MILWAUKIE PLANNING COMMISSION Tuesday, June 25, 2013, 6:30 PM

- 5.0 Public Hearings** – Public hearings will follow the procedure listed on reverse
 - 5.1 Summary: Setback Variance
Applicant/Owner: Ron Woodruff/Perry Nordby
Address: 9925 SE 37th Ave
File: VR-12-05
Staff: Li Alligood

File: Variance, VR-12-05
Site: 9925 SE 37th Ave, Milwaukie, OR 97206
Re: Revised Incompleteness Letter

Re: Response to May 23 clarification of Type III Appeal info.

SITE PLAN # EXHIBIT #2 [REQUEST #1(A)]
SC. 1/16" = 1 FT

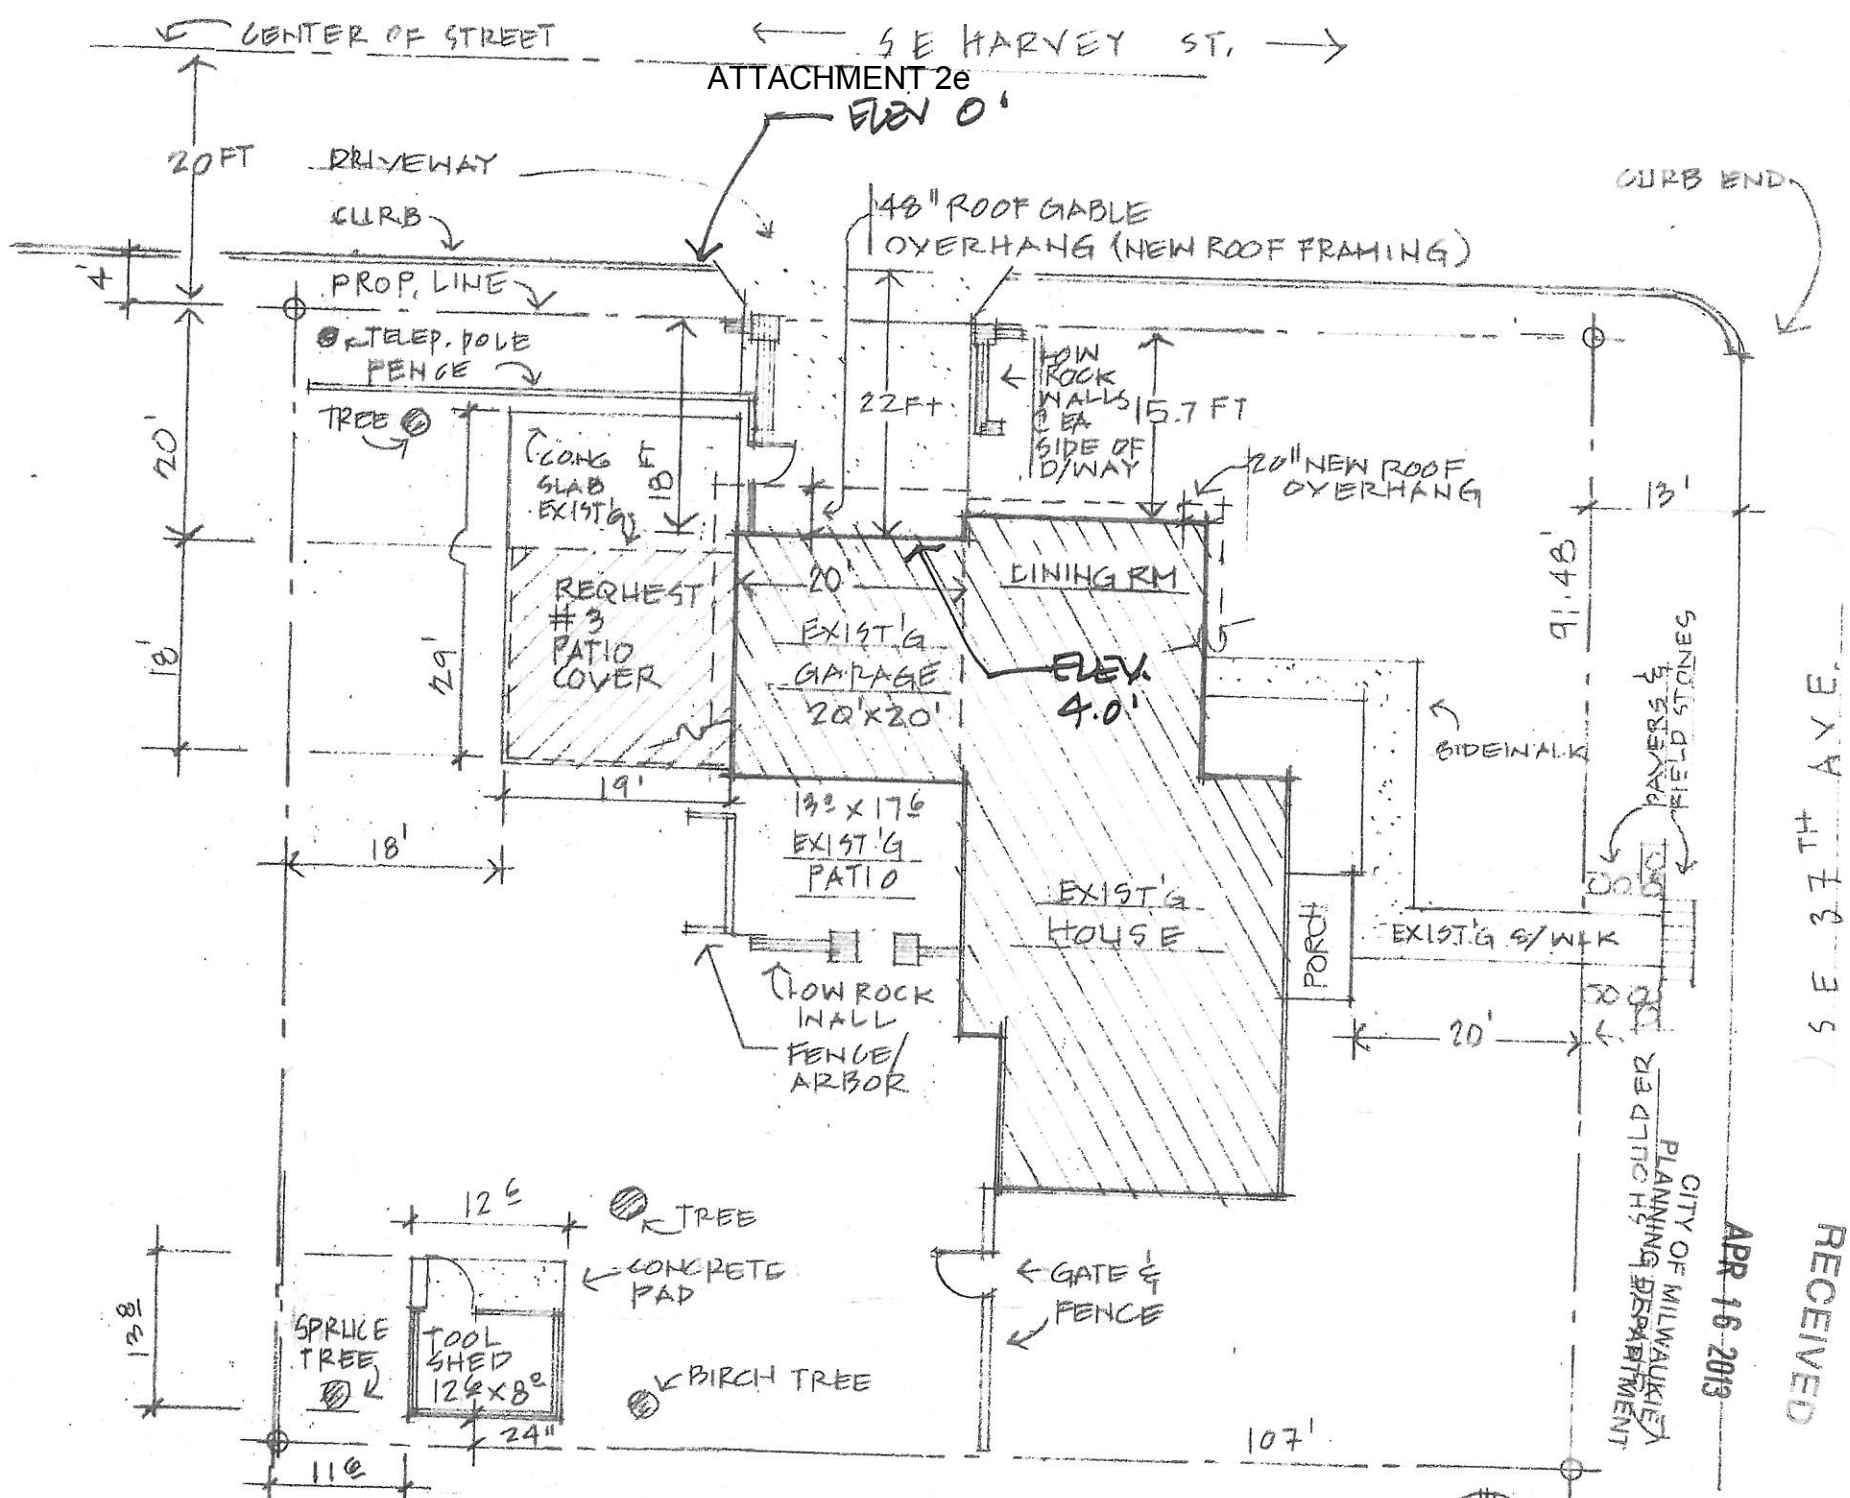
- A) On SE Harvey side of street (north facing elevation), request to extend existing garage footprint 36" toward Harvey Street (see site plan Exhibit #2) accompanying that footprint expansion is a gable roof overhang of 30" (see note on site plan Exhibit #2)

ANSWER: The north side garage expansion or the requested roof gable extension with the original garage footprint is not anticipated to be in conflict with any of the above criteria unless there might be a problem with the garage footprint expansion of 36" leaving a setback to property line of 15 ft and 19 ft. to street curb line.

ANSWER: As mentioned previously, extension of the garage to the north side would preserve the daylight exposure to the west wall windows of the living room in the existing house and prevent moving existing plumbing utilities in the expansion if we had to expand to the south instead of to the north side.

SITE PLAN - EXHIBIT # 1 [REQUEST # 1 (B)]
 SCALE 1/16" = 1 FT. 9925 SE 37TH AVE

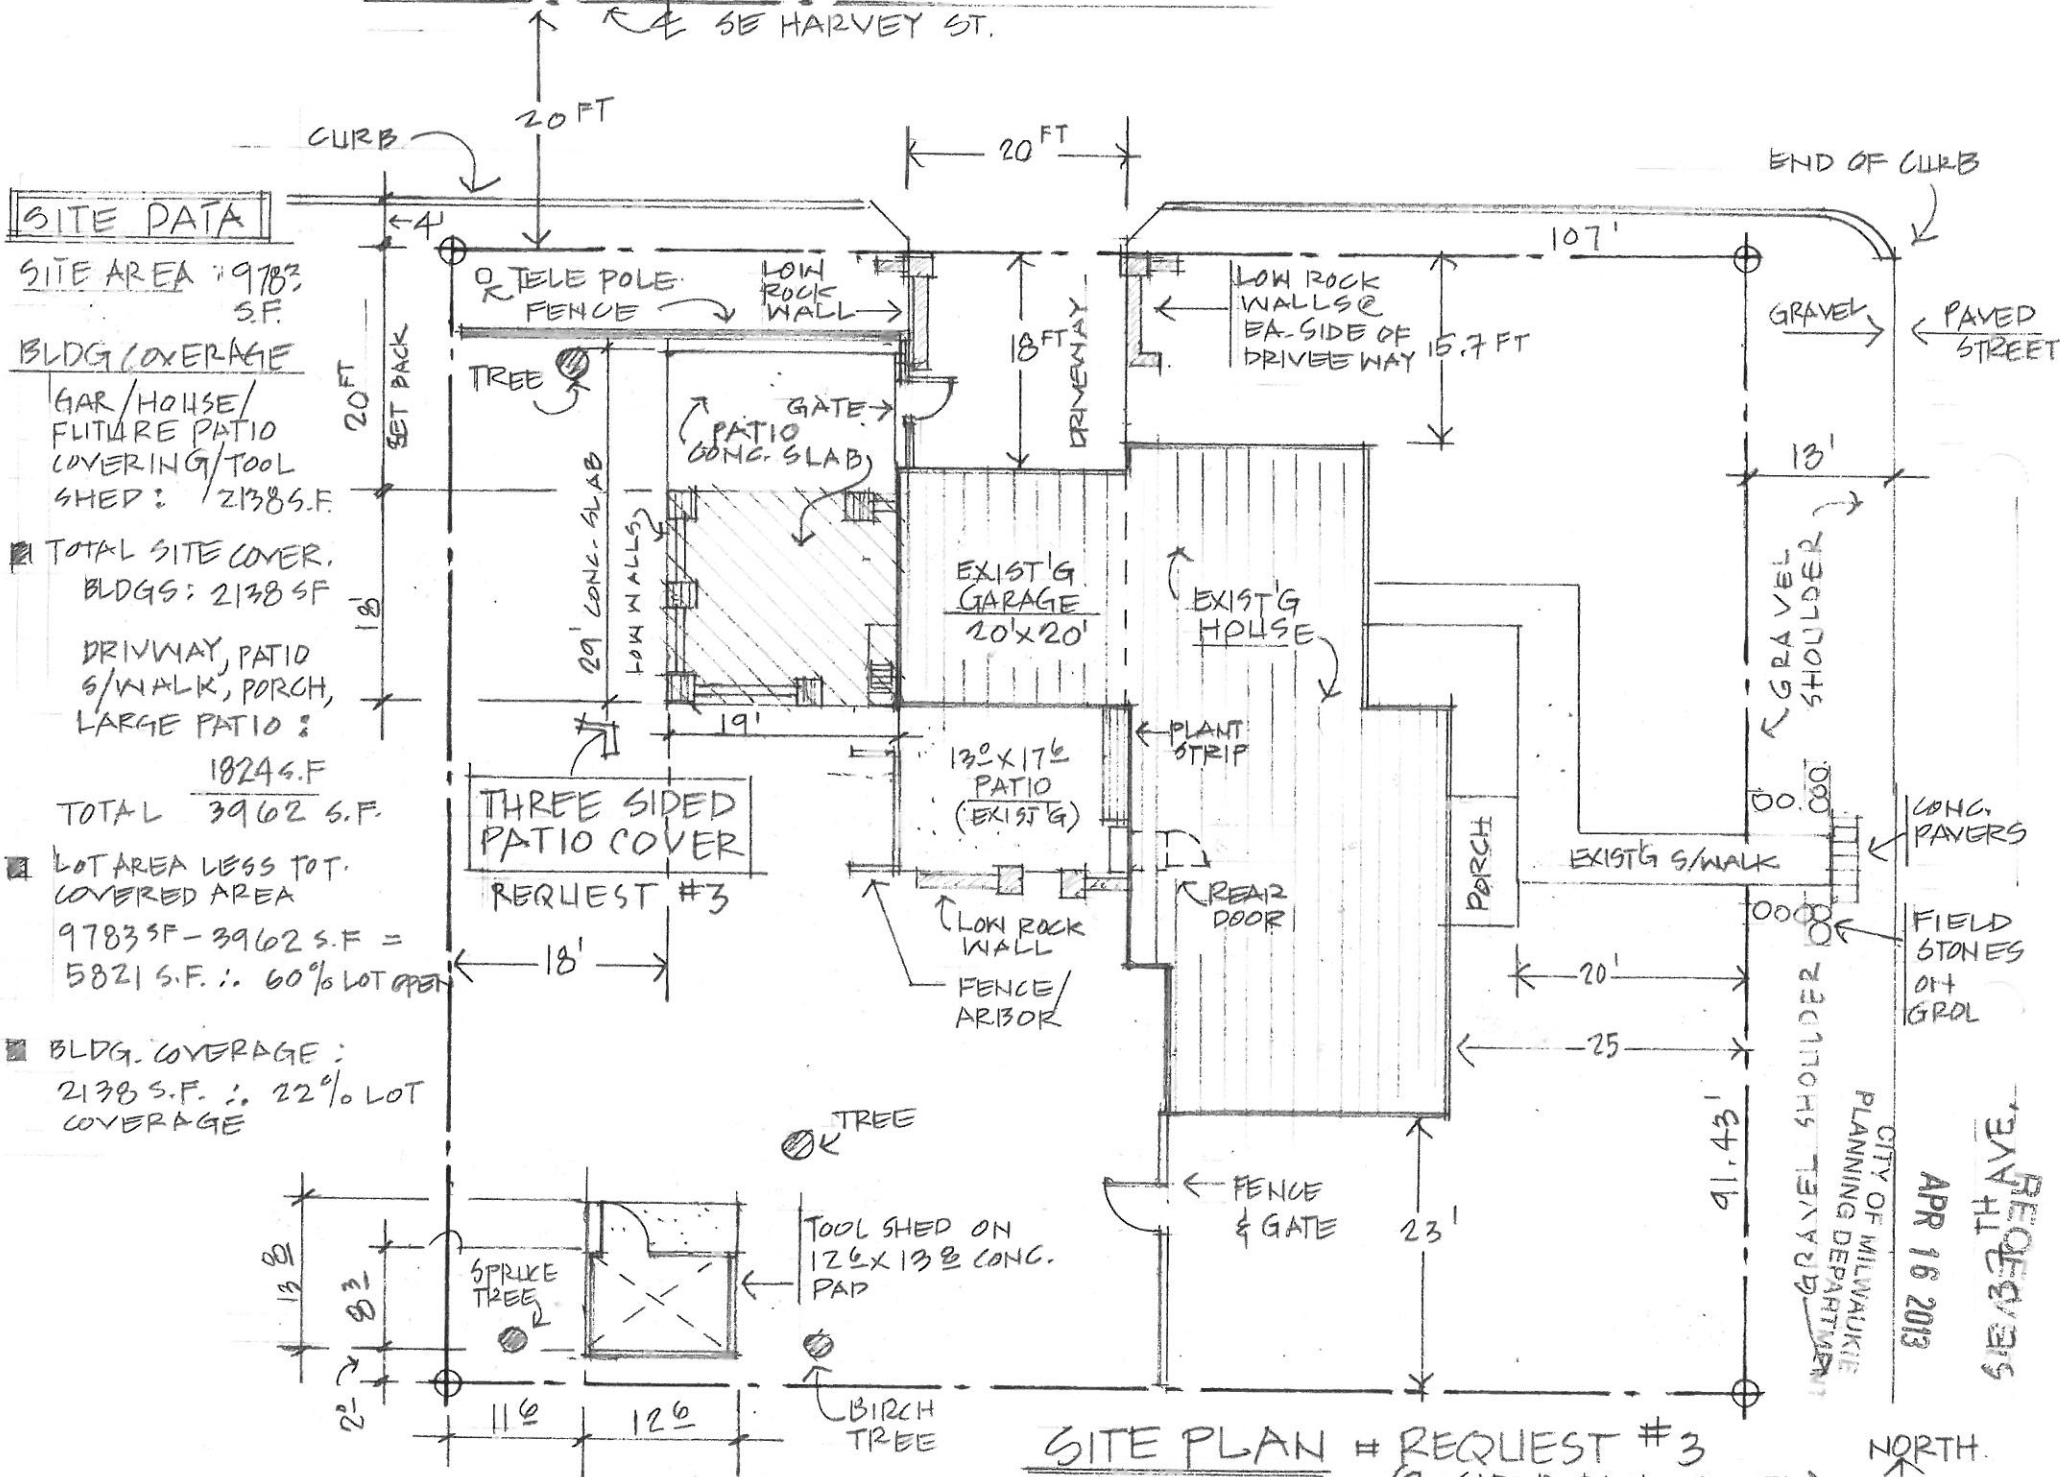
- B) Variation of previous request (A) : If previous above request is not acceptable...is to leave garage footprint as it exists (see site plan Exhibit #1) and request that a gable roof overhang be constructed at 48".
(North side elevation sheet Exhibit #4 shows the same concept for front view. Also, see Exhibit #3 and #5 West Elevation at Garage and Typical Knee Brace for proposed roof gable extension of 48")

NORTH ELEVATION

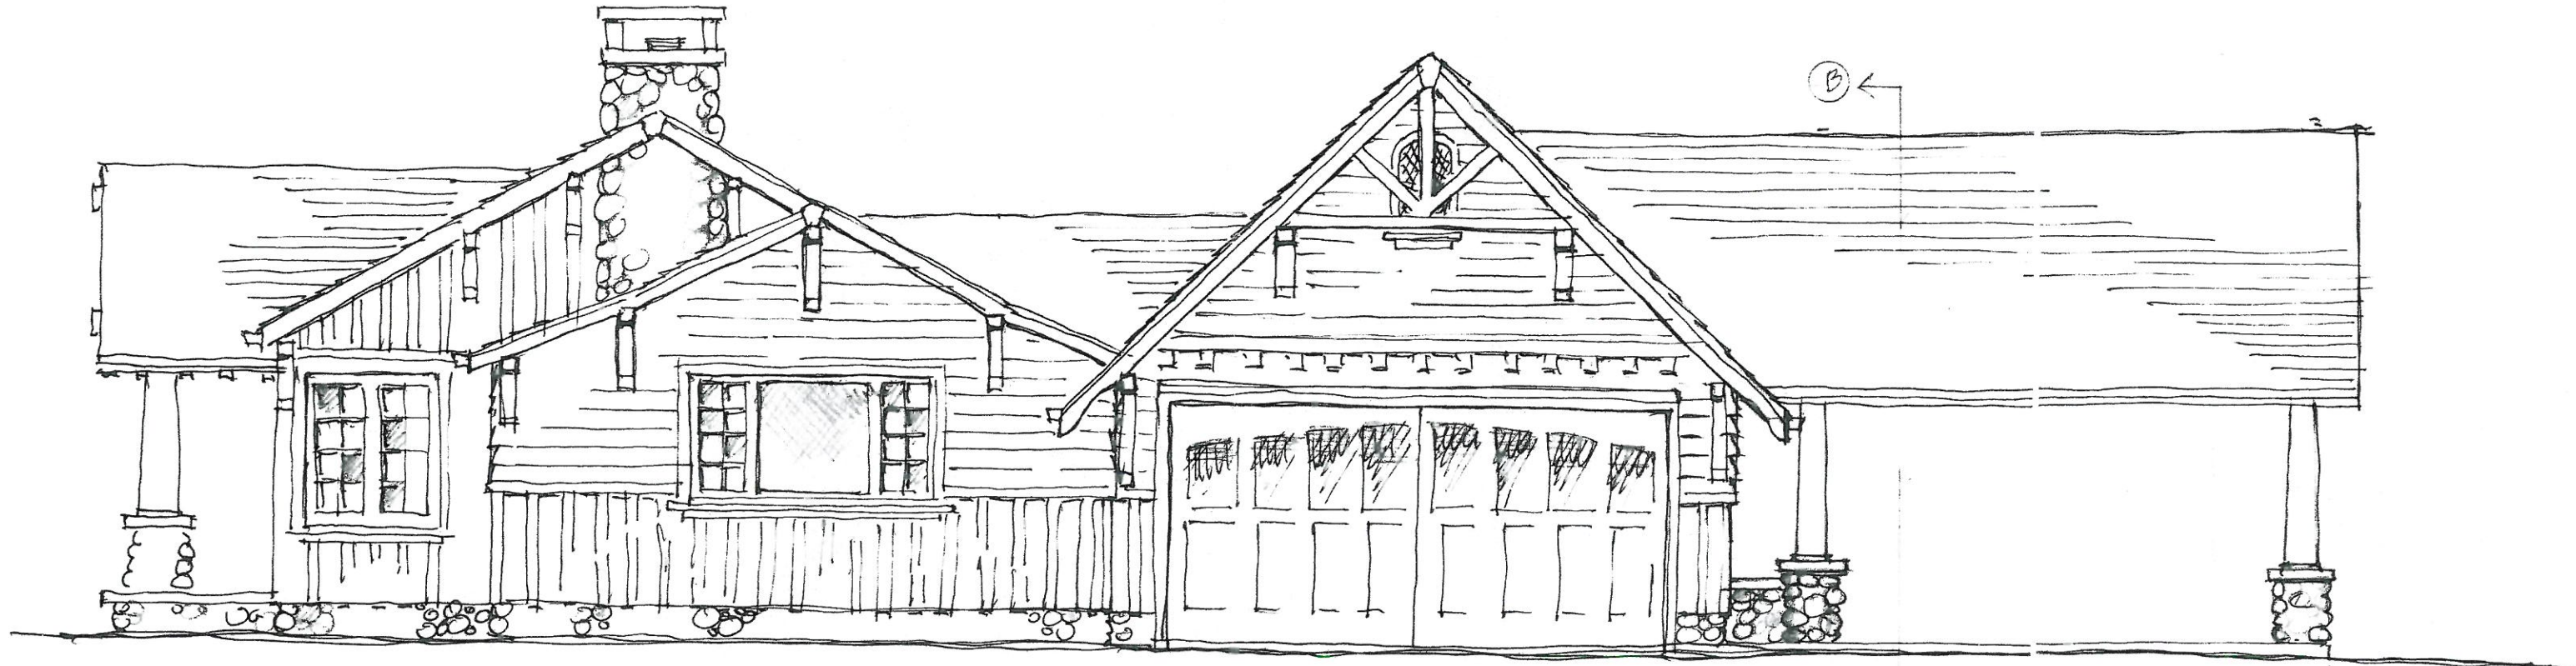
See North side elevation, Exhibit # 4 for view of garage modifications. Garage roof is proposed to be re-framed in steeper pitch than existing the roof pitch which can be seen as a dotted line in the drawing.

Explanation: The existing roof construction of this early post-war house had no gable/roof overhangs to protect the north wall from the weather. Since the house will be re-roofed, we are requesting that the dining room side of the north side elevation have a 20” gable extension/overhang of the roof. See the following Exhibits: Site plans #1 and #2 at labeled “Dining Room” area, Exhibit # 4, North Elevation, Exhibit # 6, Roof Plan.

Answer: The roof overhang as can be seen on Exhibit # 4, North Elevation, with the knee brace supports...will continue to enhance the overall house upgrade. No impacts to surrounding properties are anticipated with the roof construction.
